971 Richmond Road, Marsden Park

ISSUE E - AMENDMENTS - 15.07.21

DEVELOPMENT APPLICATION

Proposed Mixed Use Development

D Section DD - Blocks
E & B 1:400 @ A3

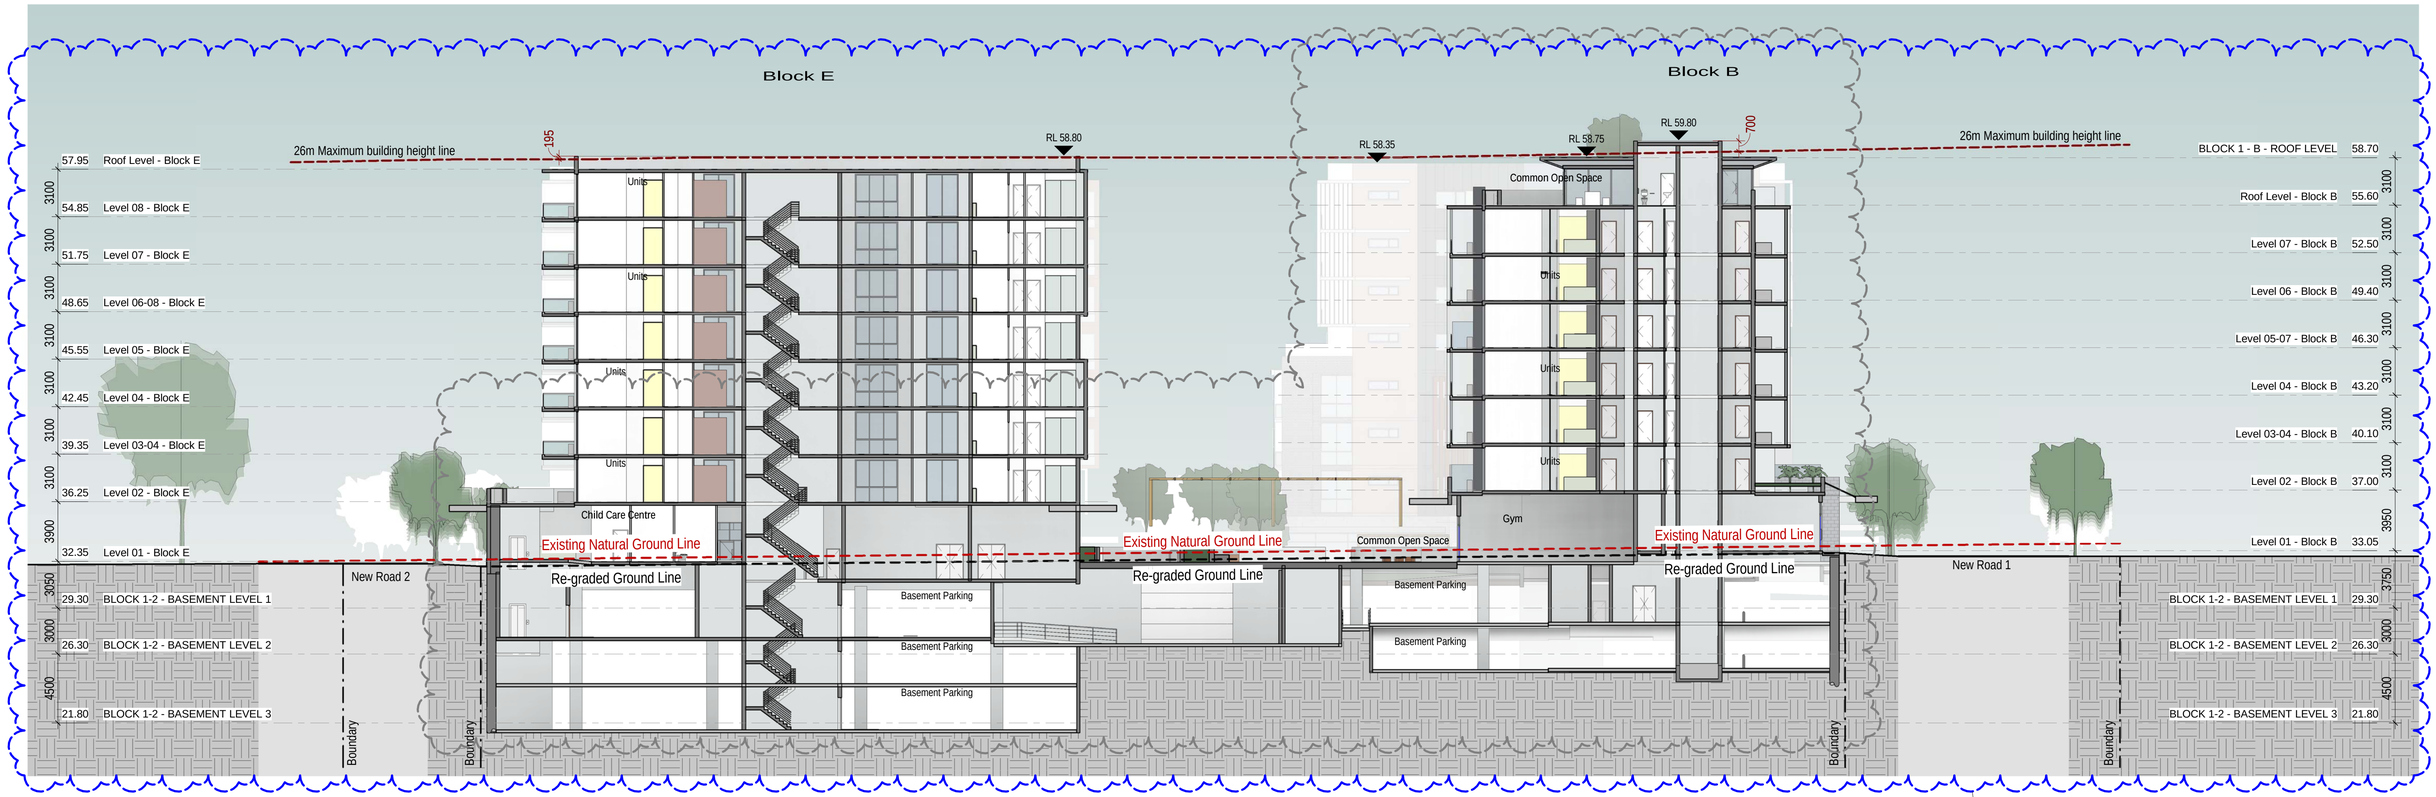
ISSUE D - AMENDMENTS - 02.06.21
1. Sections amended to follow changes in Floor Plans
ISSUE E - AMENDMENTS - 15.07.21
1. Sections amended to follow changes in Floor Plans. 2. Regraded Ground Line extracted from revised Civil drawings and added to the Sections. 3. Building RLs amended (lowered) to reflect amendments to Civil Drawings. 4. Sections AA and BB updated to show to batter adjacent to Western boundary.

1 Level 04 - Solar Access & Cross Ventilation 1:400 @ A3

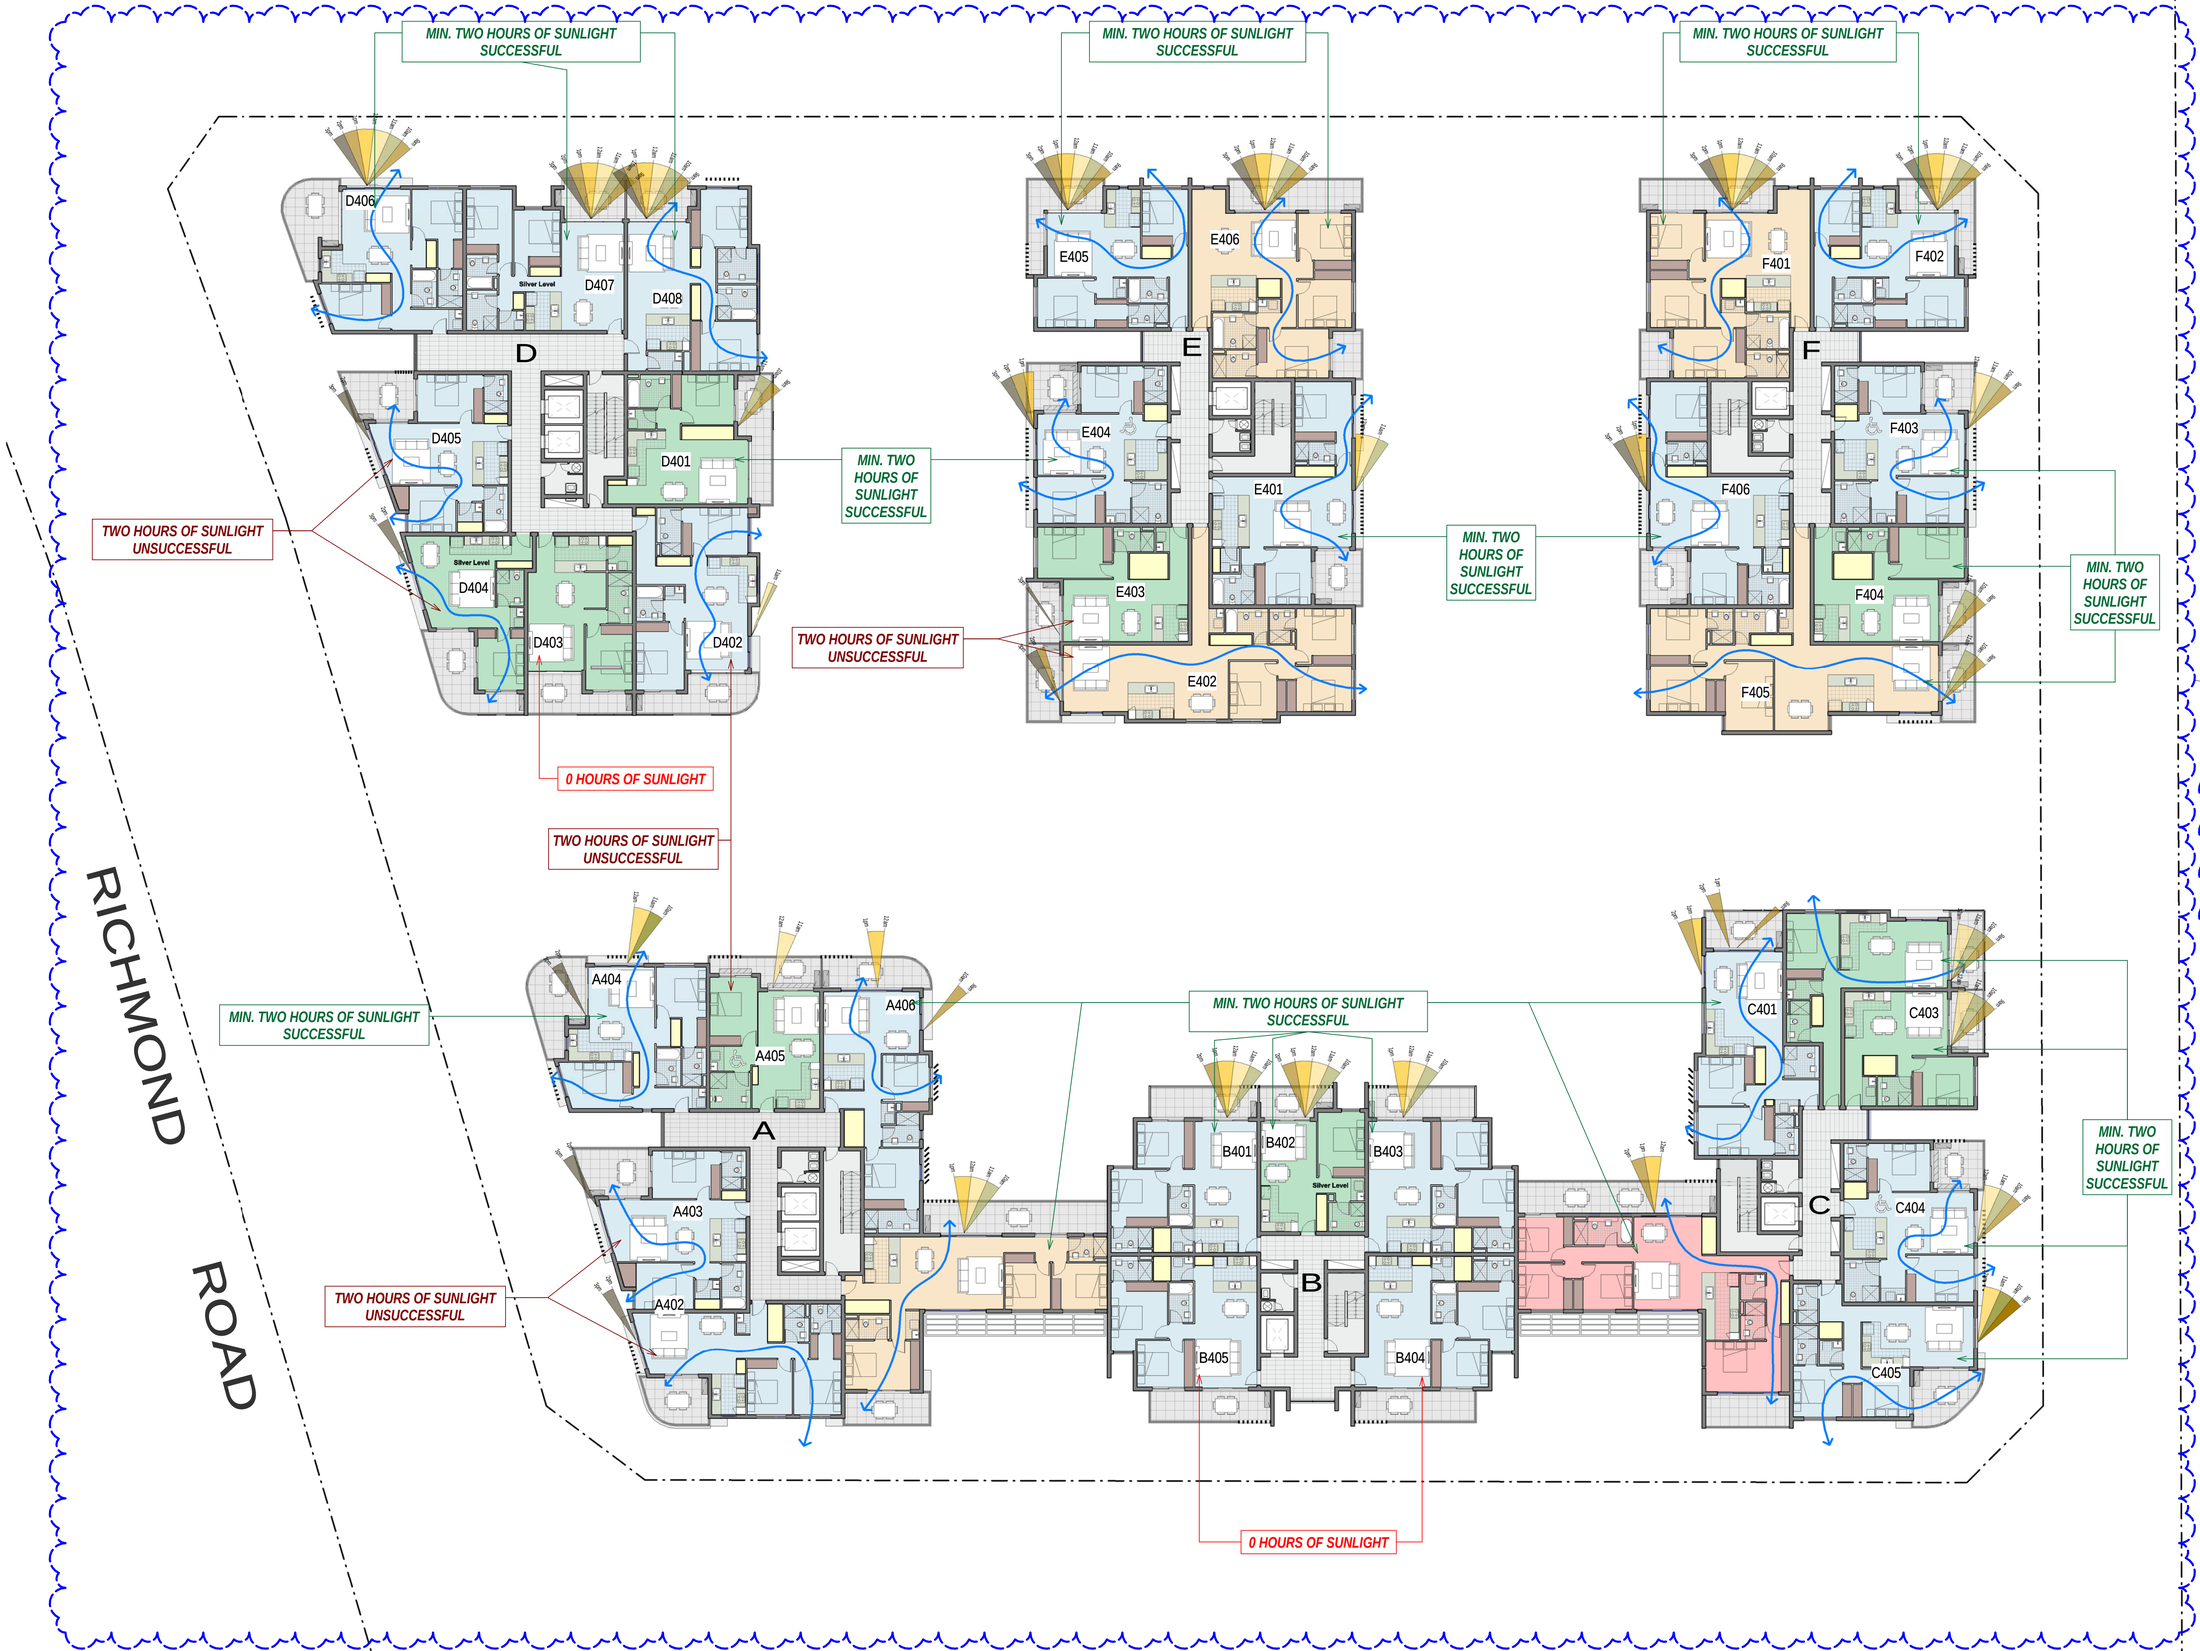
1. Solar access and Cross-ventilation diagrams updated to reflect updated floor plans.

1 Level 06-07 - Solar Access & Cross Ventilation 1:400 @ A3

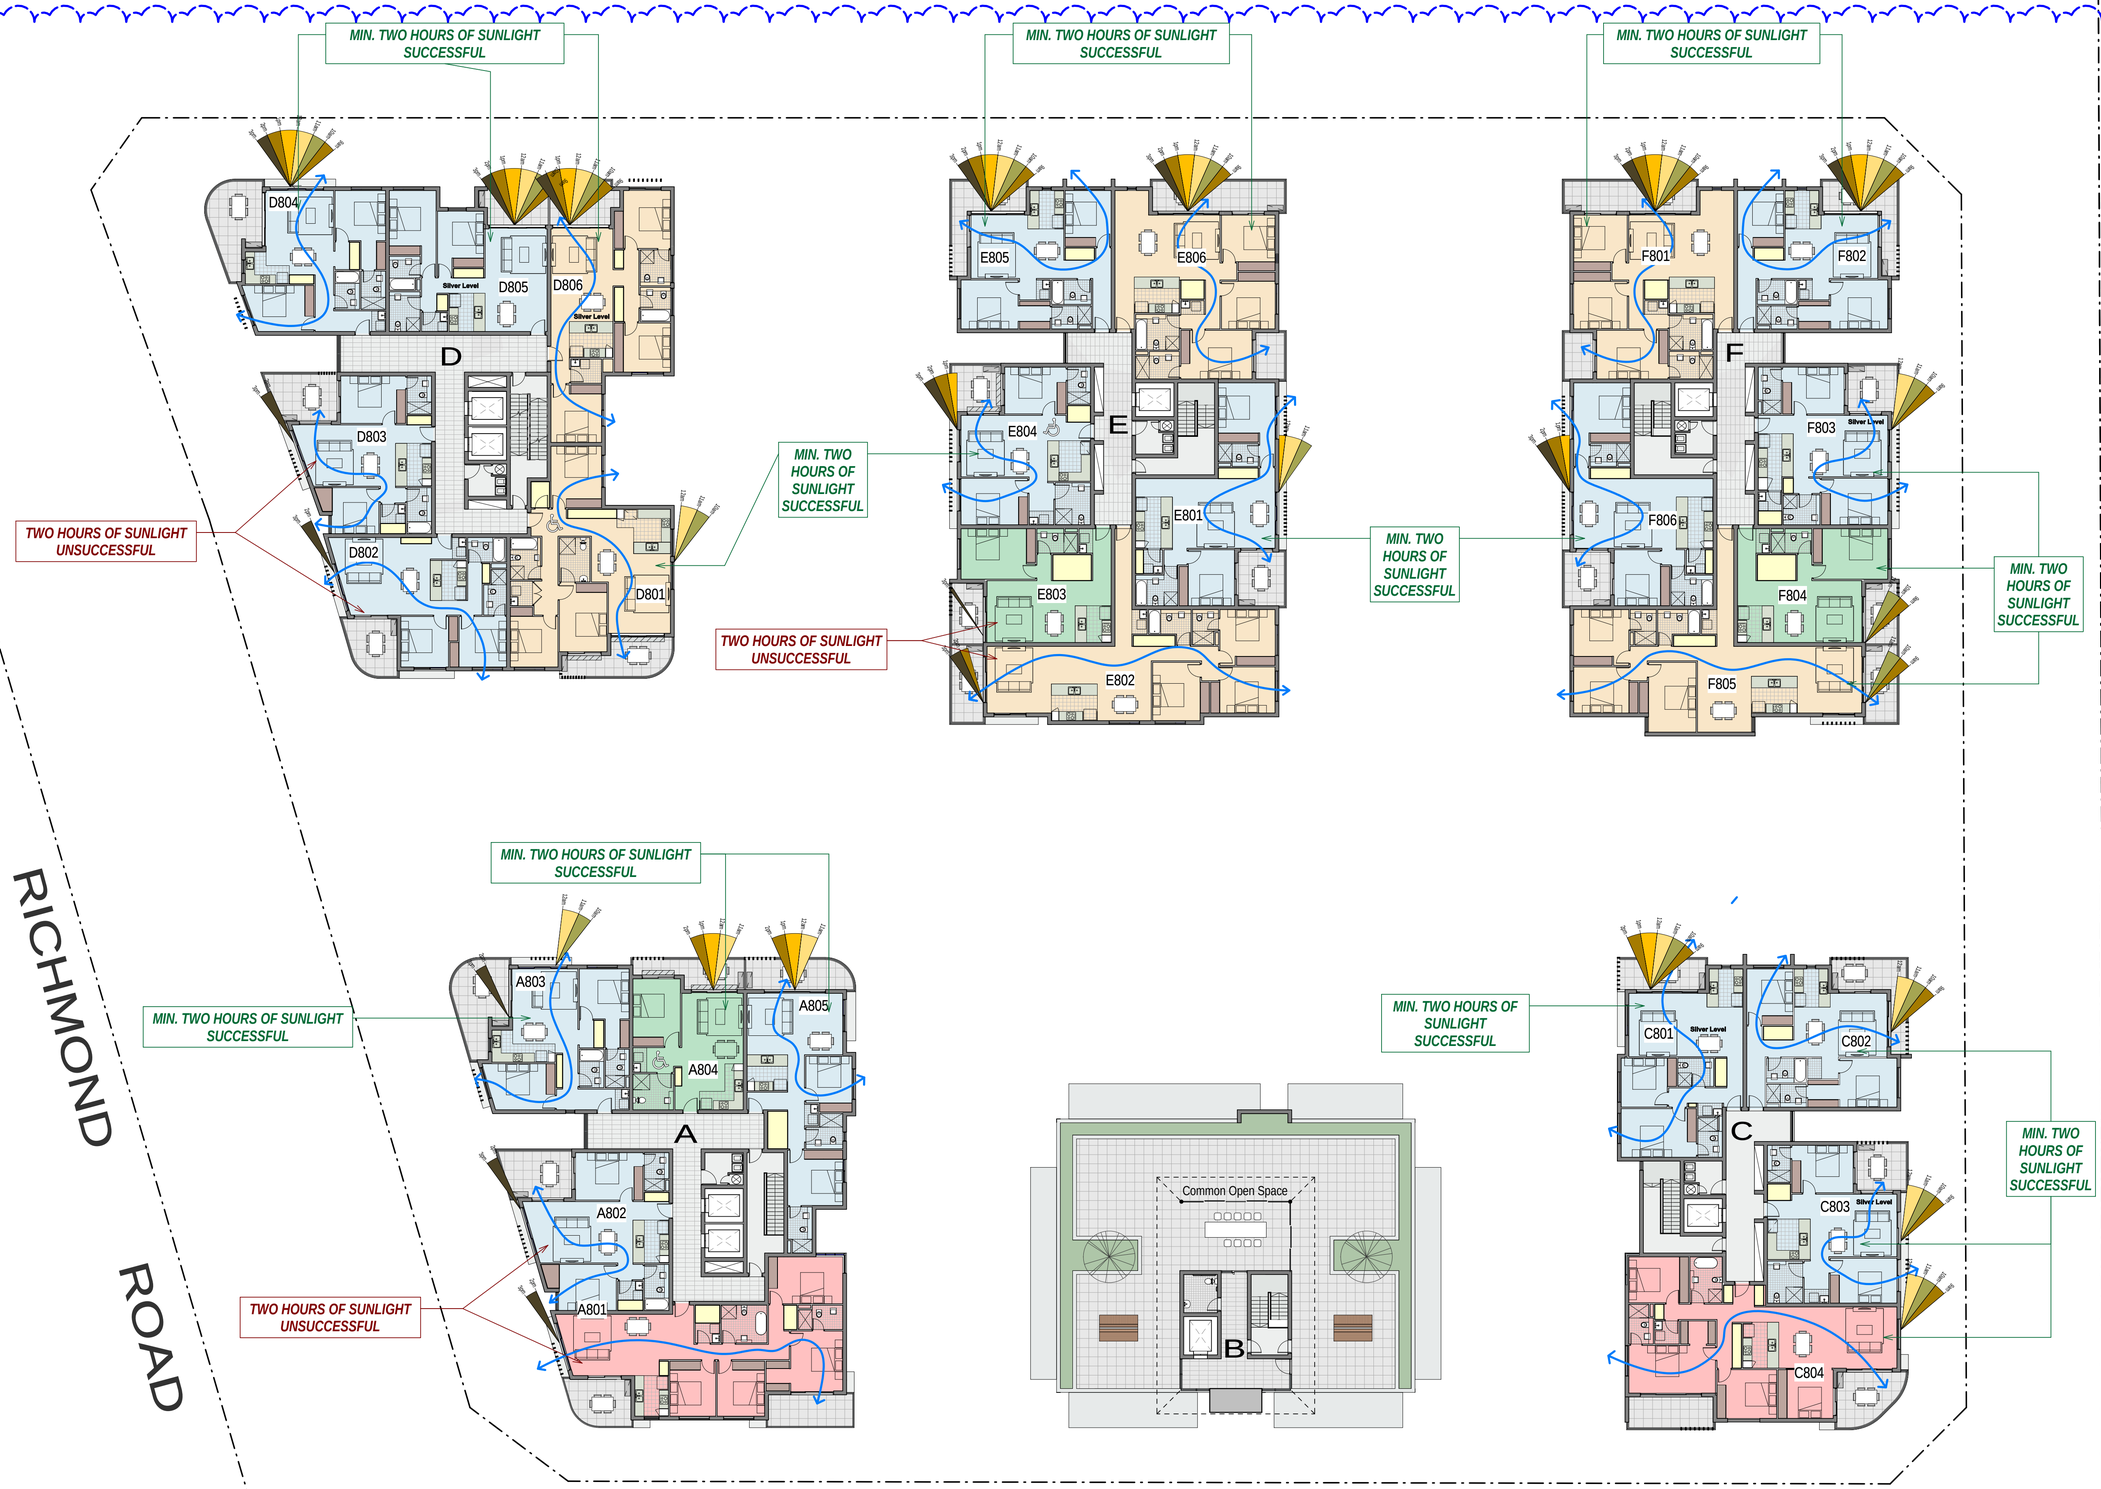
1. Solar access and Cross-ventilation diagrams updated to reflect updated floor plans.
